Addendum No. 2
October 16, 2023

Project: **Harrisburg South Middle School Theatre Addition**
Harrisburg, South Dakota
Architecture Incorporated Project #3024

Scope of this Addendum:

DEMO UNDERFLOOR PLAN - AREA B - PLUMBING

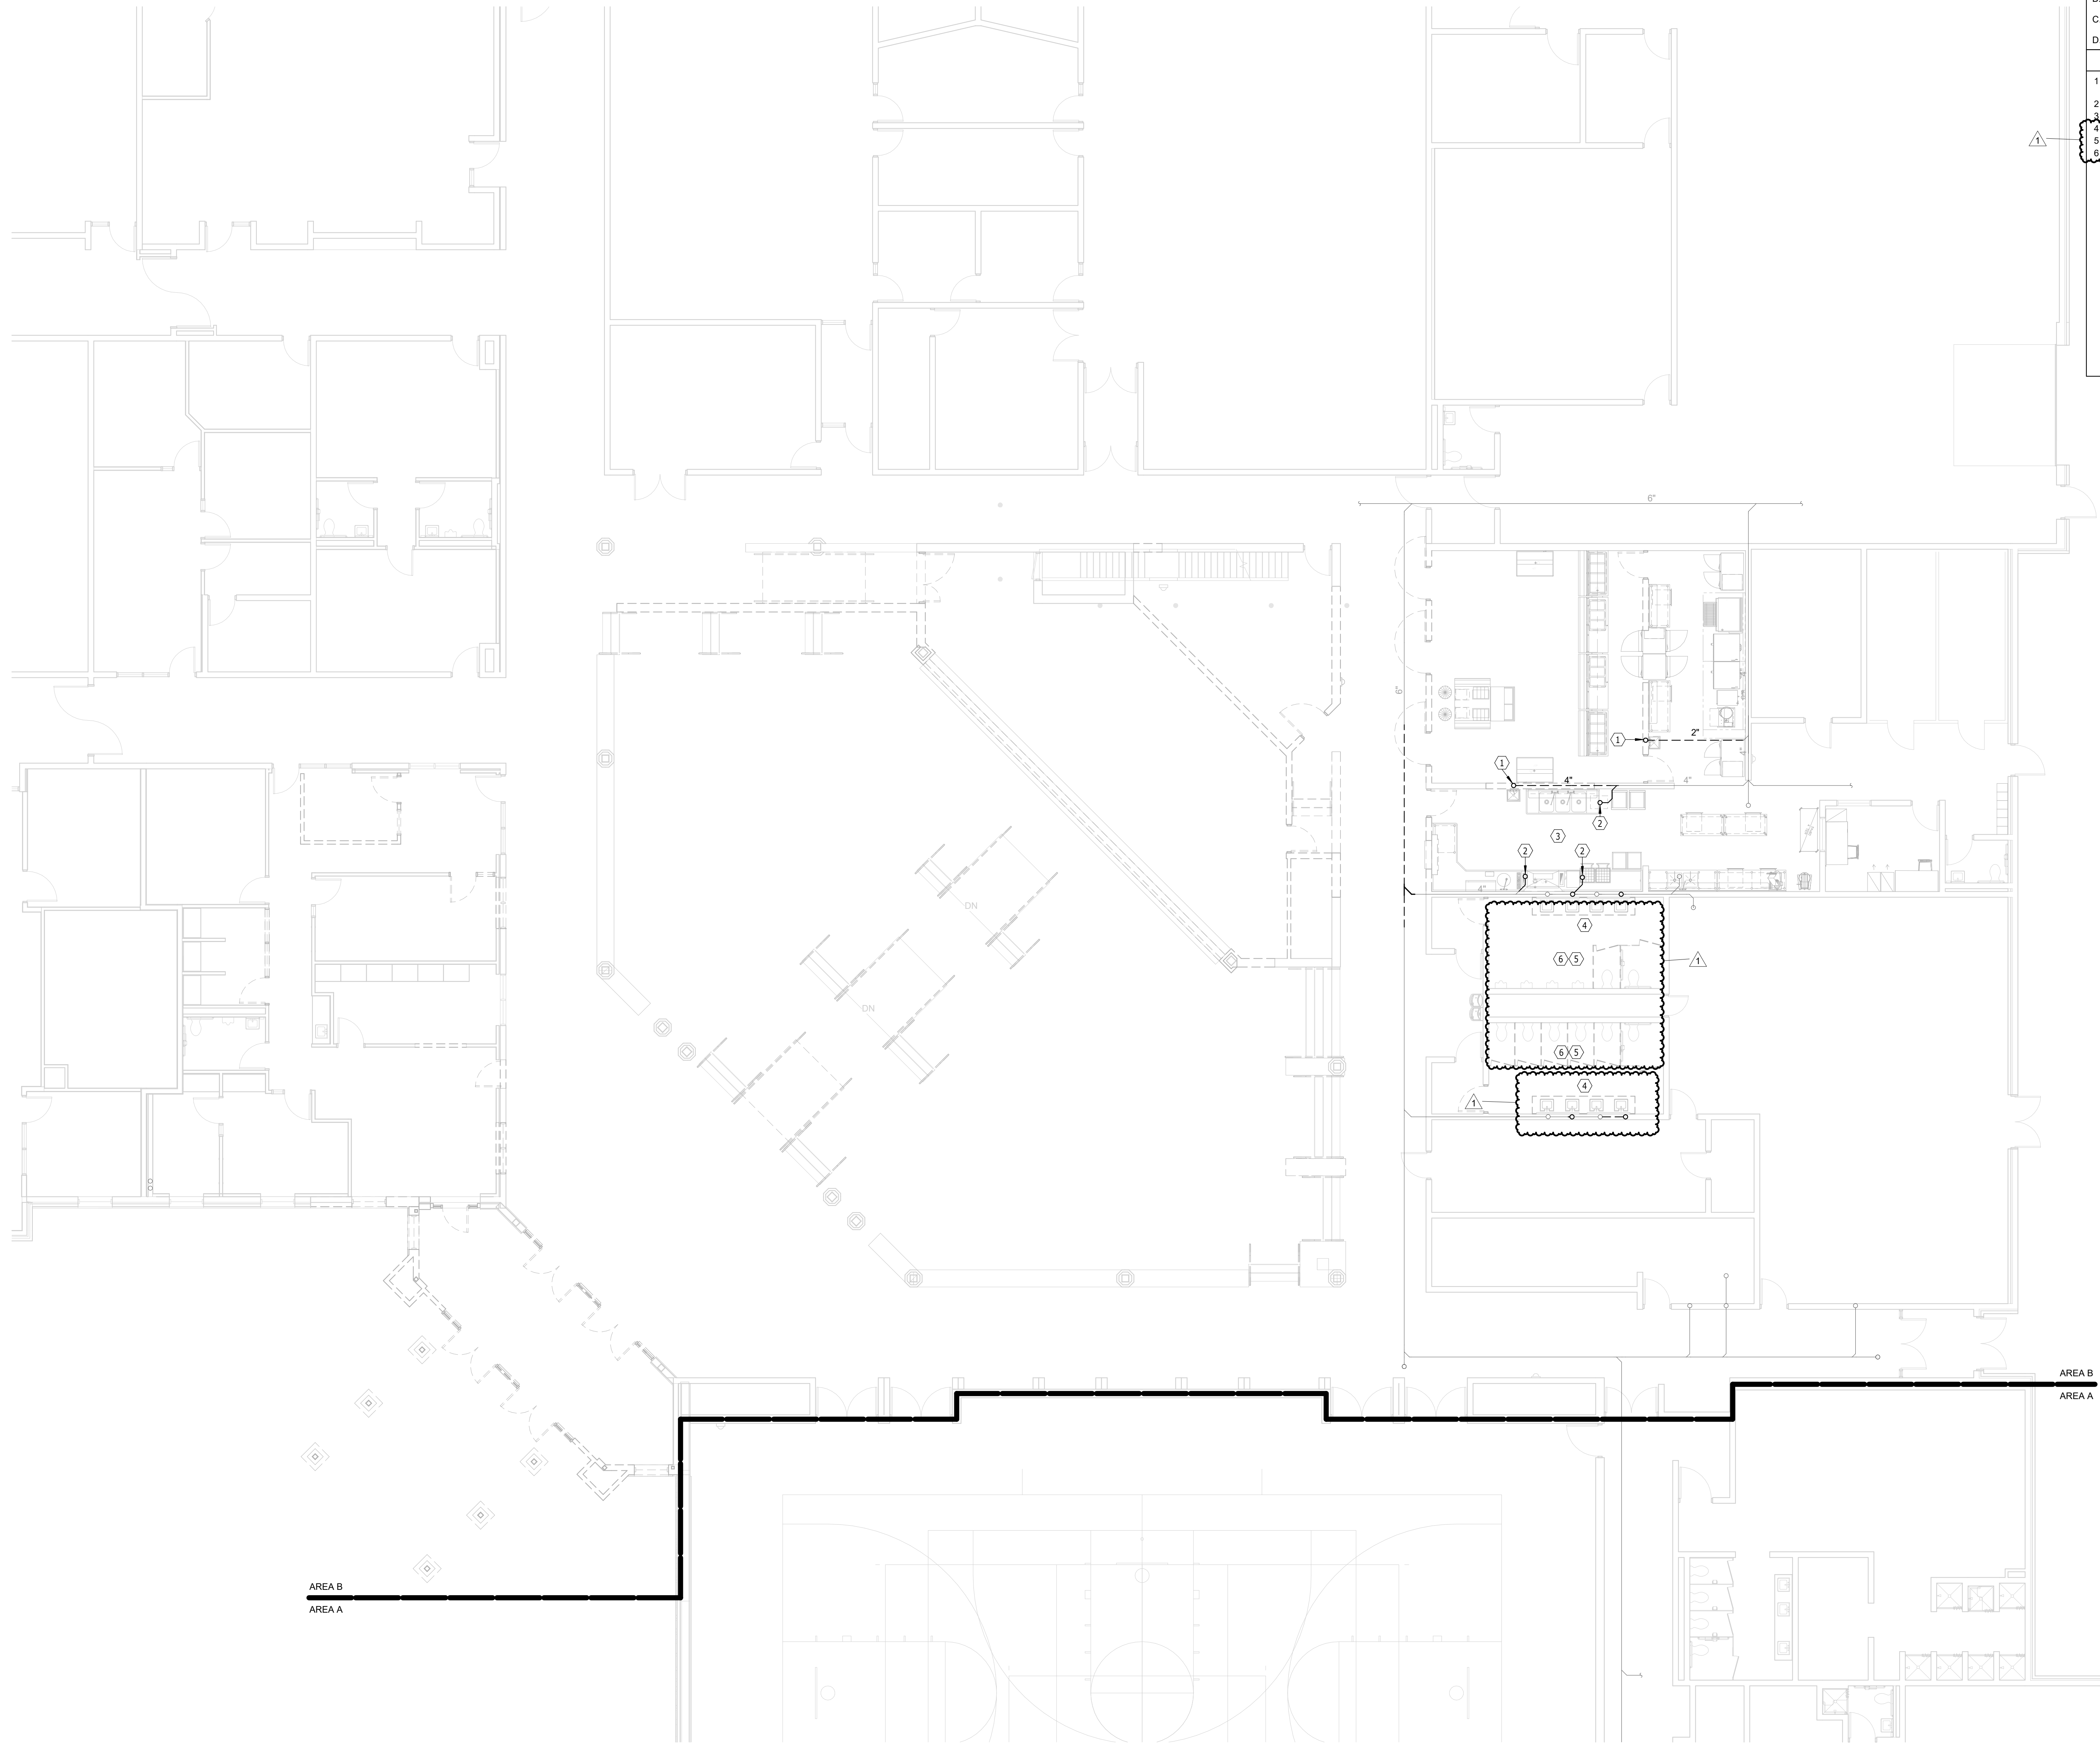
1. Modify drawings as shown on sheet 8.20, dated 10-16-23, Addendum #2.

Sheet Contents: **DEMO FLOOR PLAN - AREA B - PLUMBING & HTG**

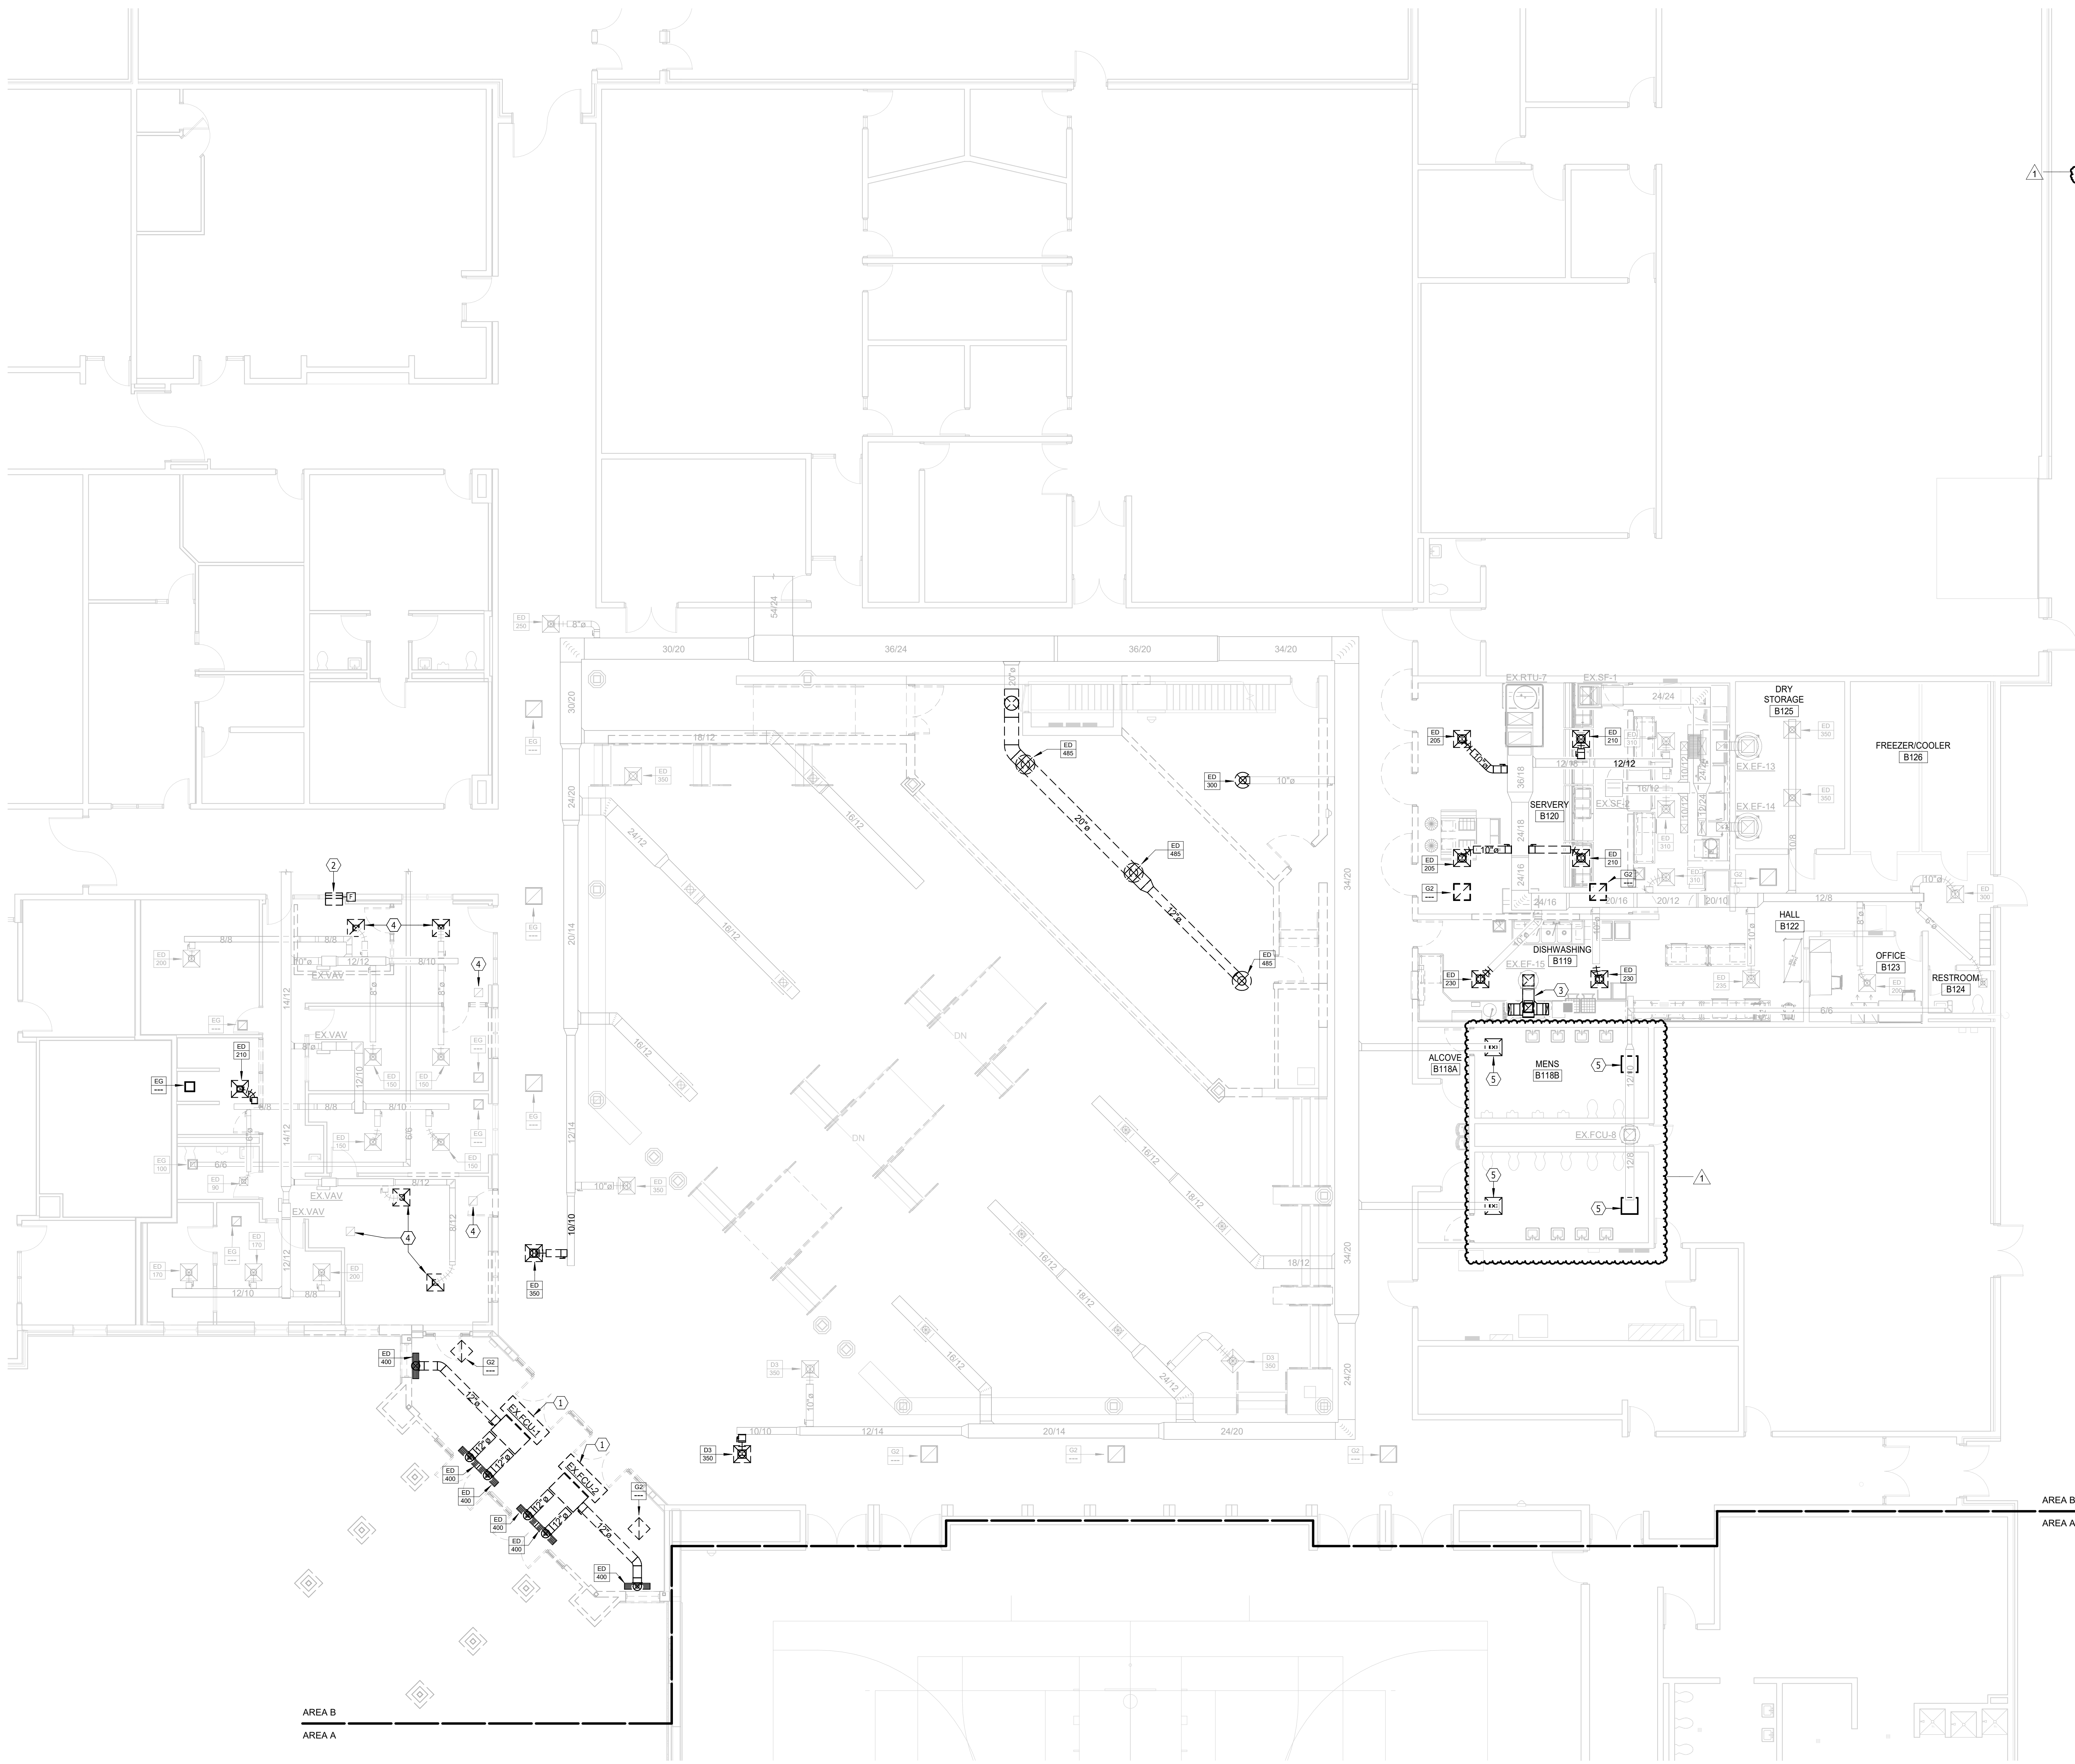
- 3) 8.21 – DEMO FLOOR PLAN – AREA A – PLUMBING & HEATING
 1. Delete Keynote 1.
- 4) 8.22 – DEMO FLOOR PLAN – AREA B – PLUMBING & HEATING
 1. Modify drawings as shown on sheet 8.22, dated 10-16-23, Addendum #2.

Sheet Contents **DEMO FLOOR PLAN - AREA B - VENTILATION & A/C**

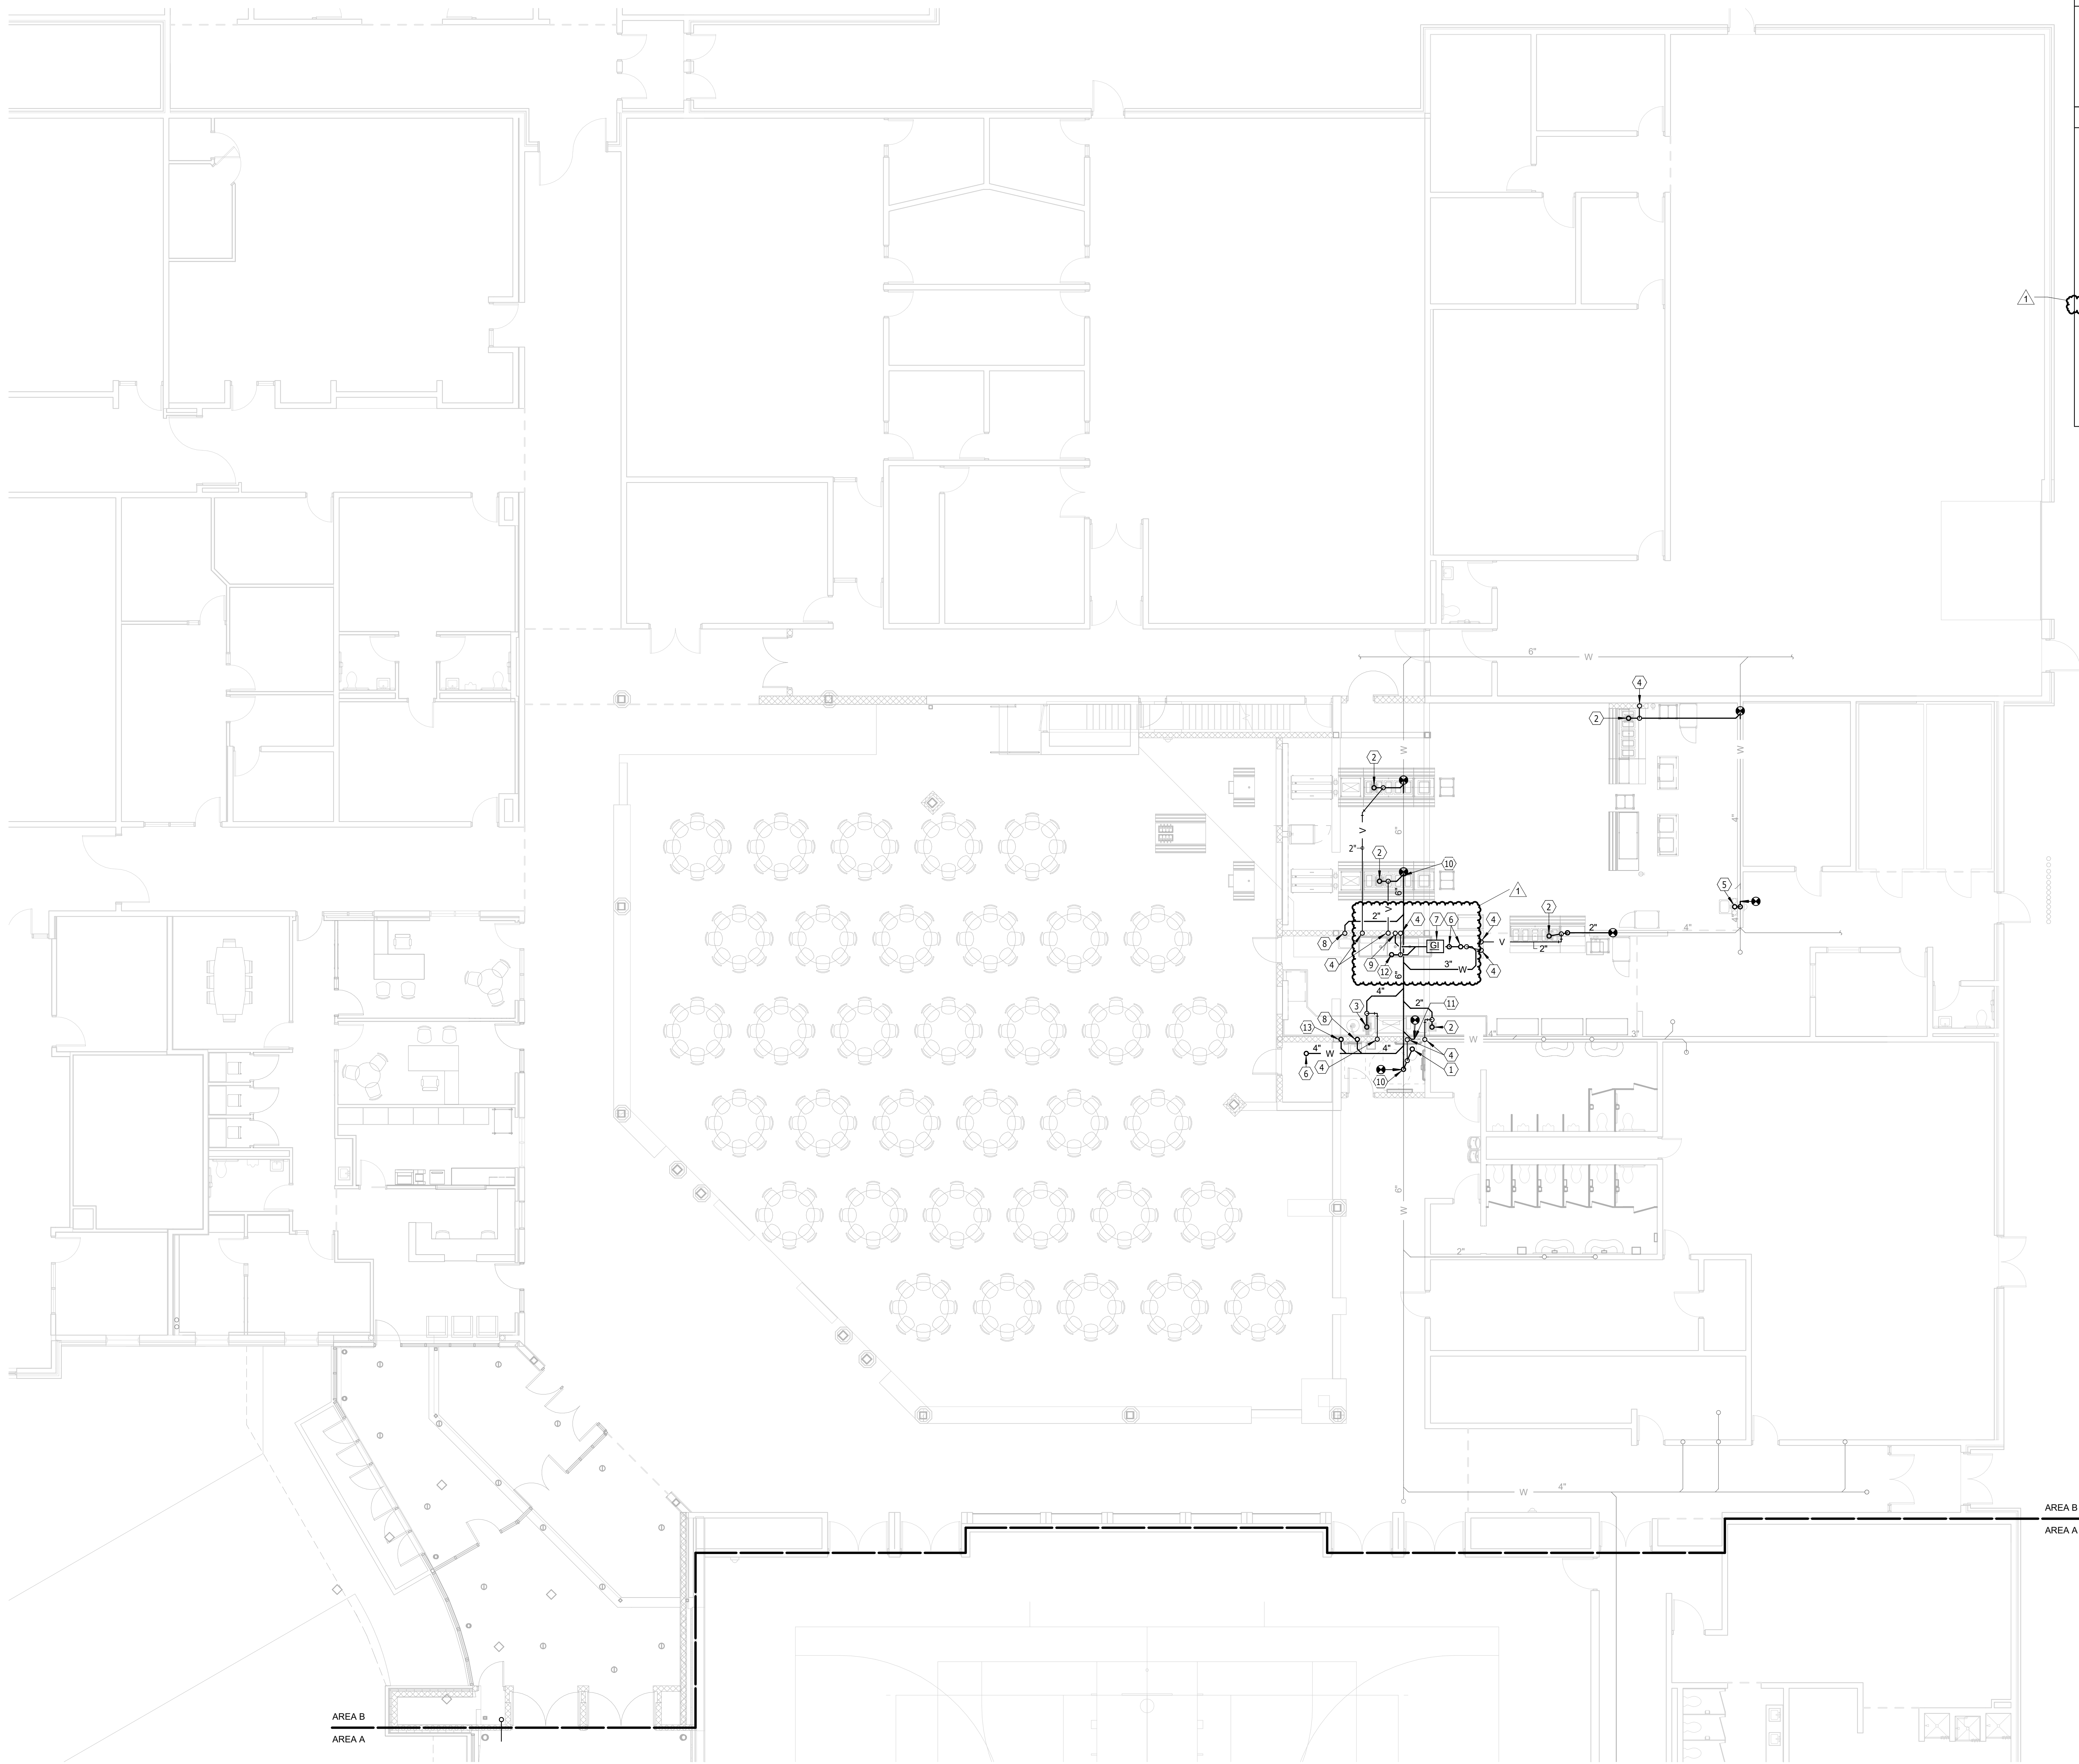
- 5) 8.23 – DEMO FLOOR PLAN – AREA B – VENTILATION & A/C
 1. Remove RGDS in B118B and B117B under alternate #1. See sheet 8.23, dated 10-16-23, Addendum #2.
